PCN-20211014 TE0802-02 LPDDR4 Change and Product Update

Company	Trenz Electronic GmbH
PCN Number	PCN-20211014
Title	TE0802-02 LPDDR4 Change and Product Update
Subject	BOM change
Issue Date	2021-11-05

This change affects Trenz Electronic TE0802 boards of revision 02: TE0802-02

#4 Change microUSB connector from 105017-0001 to 10118194-0001LF

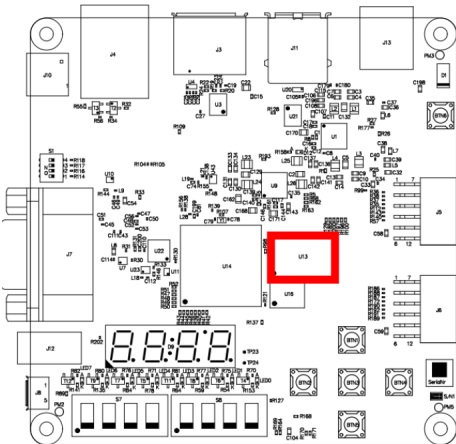
Type: BOM change
Reason: Connection problems reported with correlation to this connector.
Impact: None.
